R-2511 4B Interagency Concurrence Point Meeting Minutes

The 30% Hydraulic Review was held in order to reach agreement on concurrence point 4B for the R-2511 US-17 widening project in Beaufort and Martin Counties. The following items were discussed and conclusions reached:

4/16/2018 Sm thwrek and Jack Swamp\Alignment Options\R2511\Culvert Option 1 Sheet.dgn

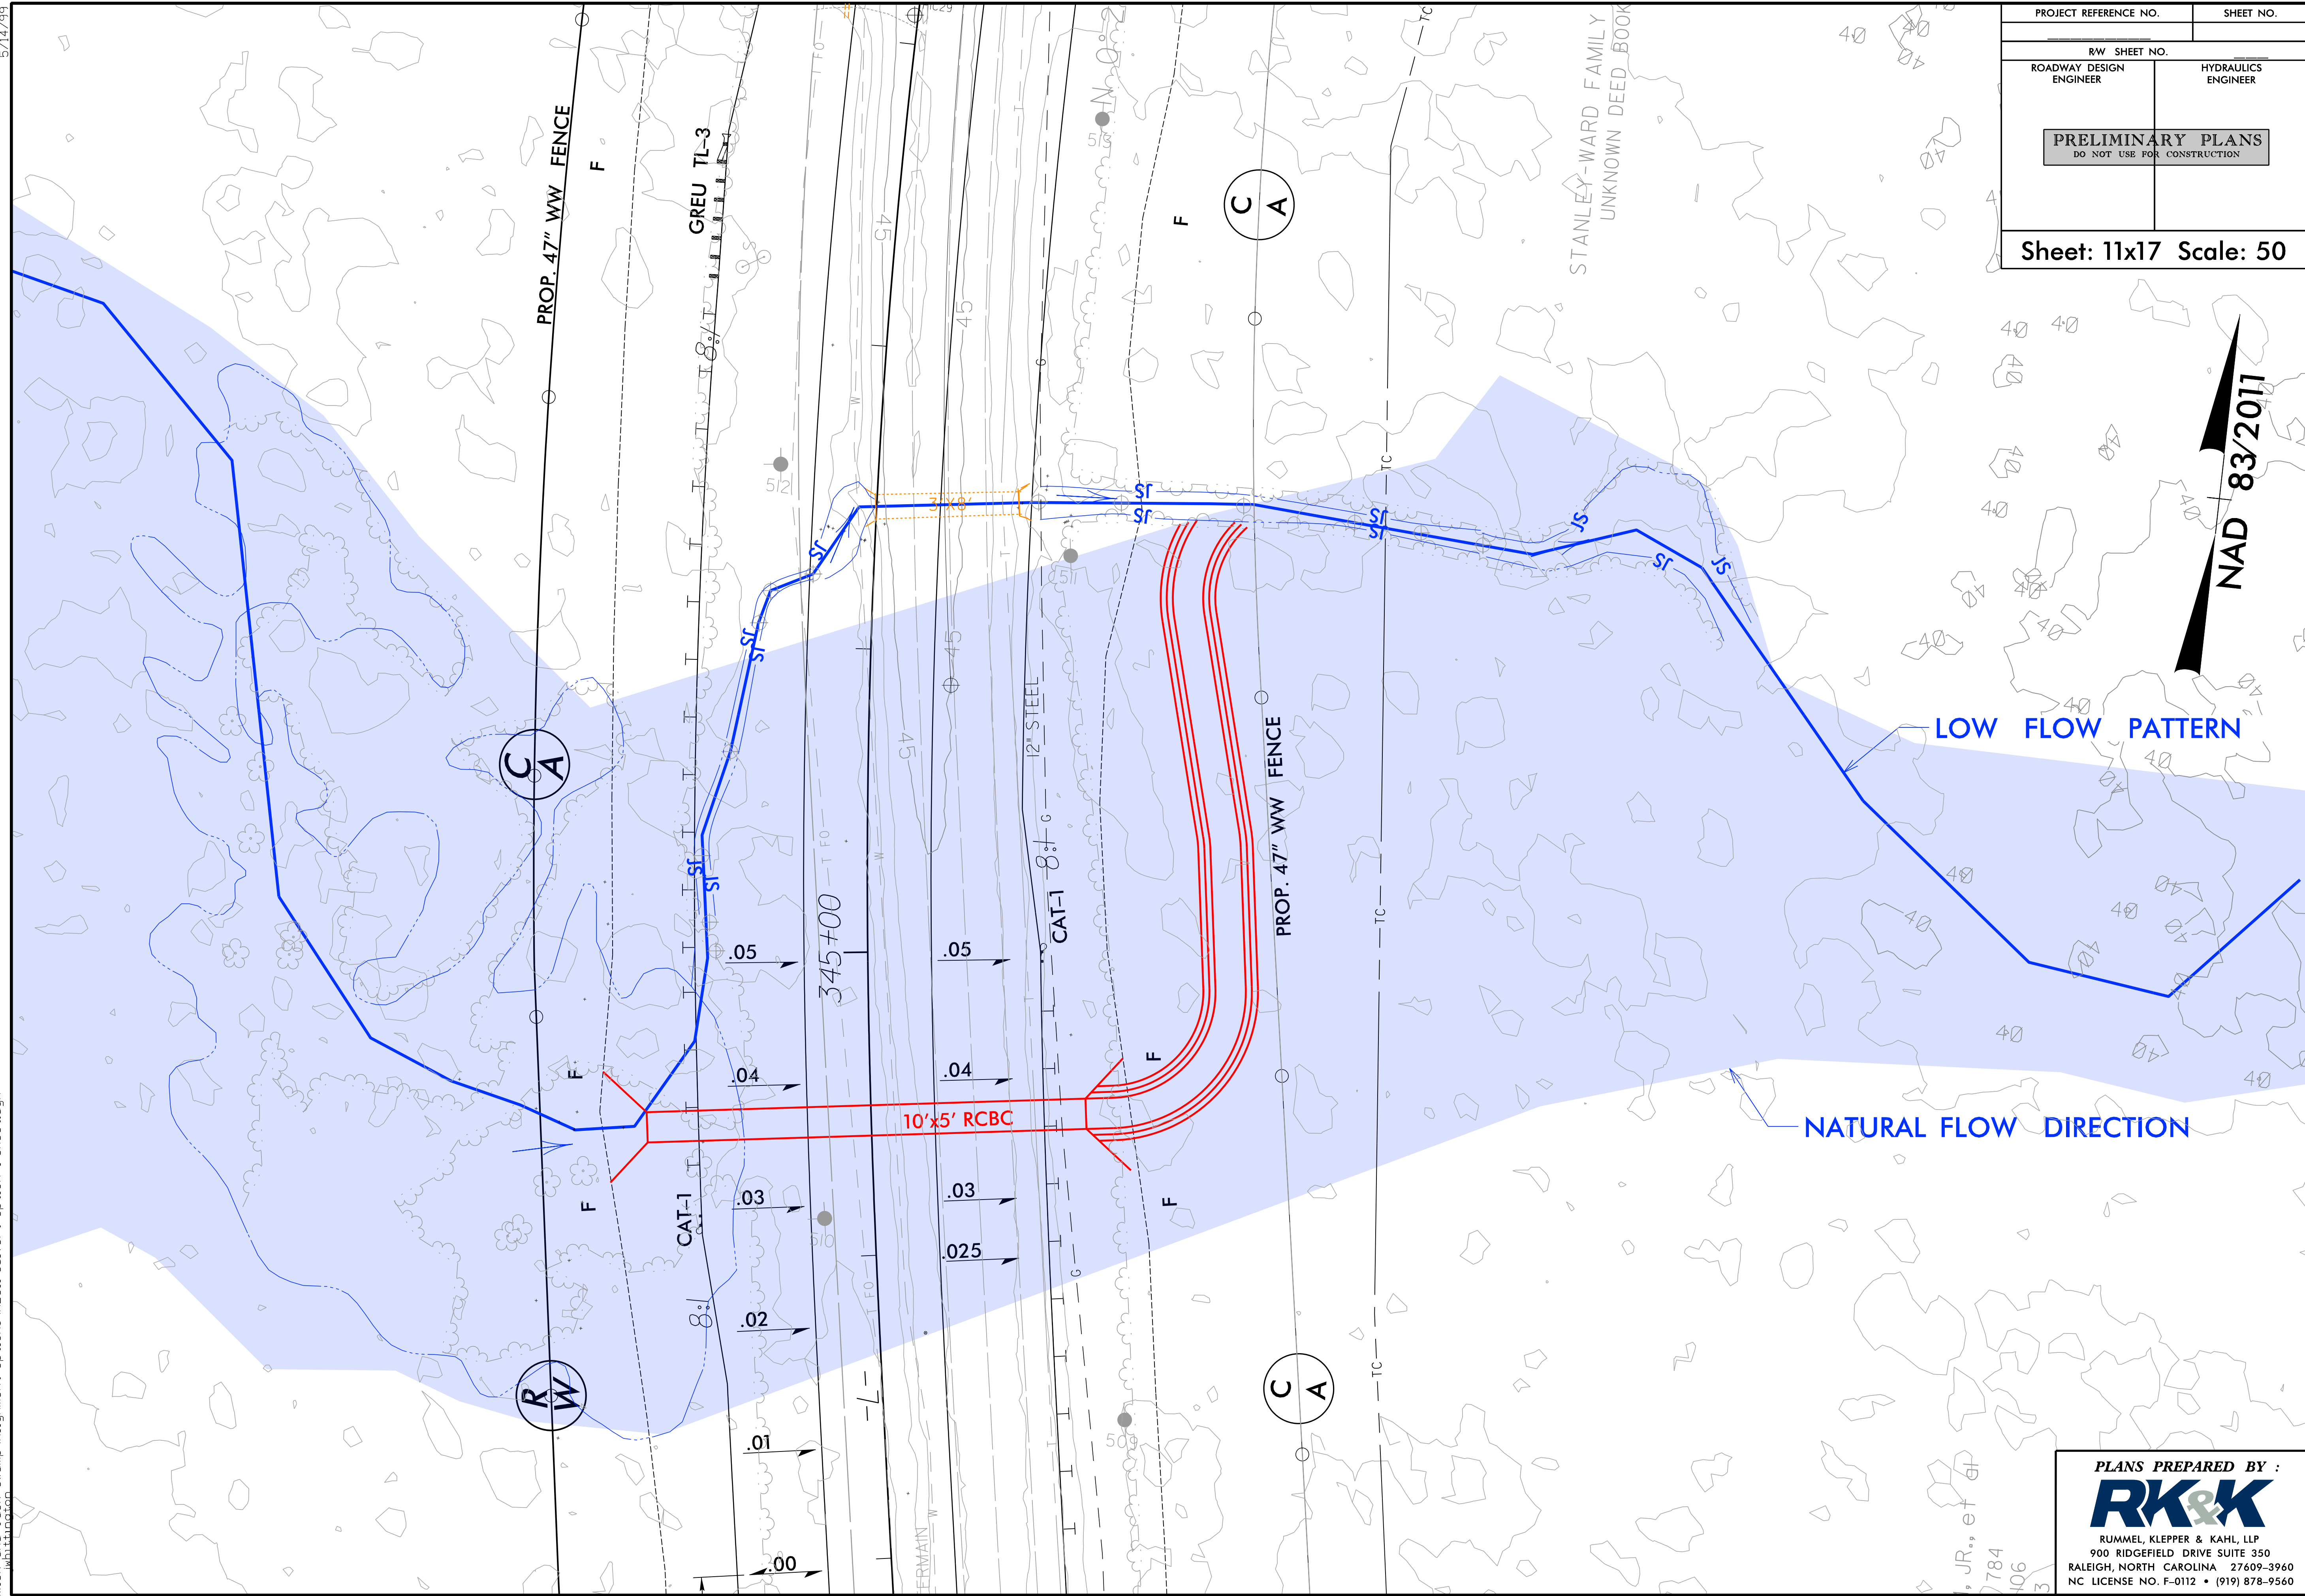
Plan sheet 30 (Stream Jacks Swamp Creek SE, wetland WF): Jacks Swamp runs west to east through the project and is currently conveyed in an 8'x3' RCBC at -L- 346+50. There will be wetland impacts up and downstream of the crossing. The 8'x3' RCBC will be removed and replaced with a 10'x5' RCBC buried 1.0' in the final condition. Mr. Cook stated that the design team is still looking at this crossing, and he presented four different options that the team is looking at for aligning the proposed culvert. The four options were as presented (and attached to these minutes): 1) aligning the culvert as shown in the 4B plans crossing at -L- 344+50 at 90° and adding an outlet channel that runs for 200' parallel to the roadway facility before tying to the stream; 2) aligning the culvert at -L- 344+75 at 70°, while leaving the inlet in the same location as option 1, and adding an outlet channel that runs for 150' parallel to the roadway facility before tying to the stream; 3) sliding the culvert up station (from options 1 & 2) and providing approx. 100' channel to the inlet with the crossing at -L- 345+75 at 70° and adding 100' +/- tail channel that gradually ties to the stream; 4) providing approx. 200' channel to the inlet running parallel to the roadway and replacing the existing culvert in the same location, crossing at -L- 346+50 at 90° and tying the outlet of the culvert to the existing stream channel.

Mr. Cook stated that the design team is in favor of options 1 and 2 since the inlet end of the culvert is being placed in the low flow pattern and the center of the natural flow direction of the crossing even though an outlet channel must be constructed that will impact wetlands. Mr. Cook stated that options 3 and 4 are not as favorable due to the fact that it would be hard to tie to the low flow area to the proposed RCBC since there really isn't a true channel to tie to. Potentially scour could also occur in the new fill slope at the location where the new channel would tie to the low area due to the sharp angle the flow would need to take. Mr. Cook stated that once an alignment is decided for the proposed culvert the model will be able to be completed since hydraulics of this culvert works together with the next site up that crosses US 17; 2,150' farther up station. This will be called out as site 8. Mr. Ward and Mr. Barnes stated that they will be going back to this site to do field verification for the JD when the site is in dryer conditions. The design team will wait for the JD field verification to move forward with the culvert design.
